# HYUNDAI Technical Service Bulletin

Group	ELECTRICAL
Number	07-01-001
Date	JANUARY, 2007
Model	TUCSON

Subject  
**TUCSON**  
**DRIVER AIR BAG COVER MODULE REPLACEMENT**  
**(CAMPAIGN 079)**

**SERVICE CAMPAIGN: SORENTO ESC REPROGRAM**

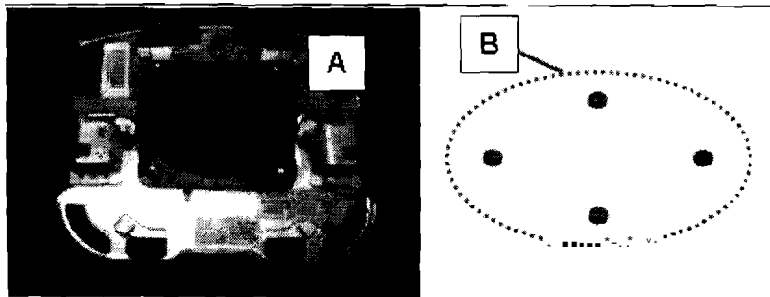
- The new DAB cover module includes the black plastic air bag inflator opening shipping protection cover (A) and four inflator mounting nuts (B) only. It does not include the inflator. Therefore, the existing inflator must be re-installed onto the new DAB cover module. Refer to the following Service Procedure.
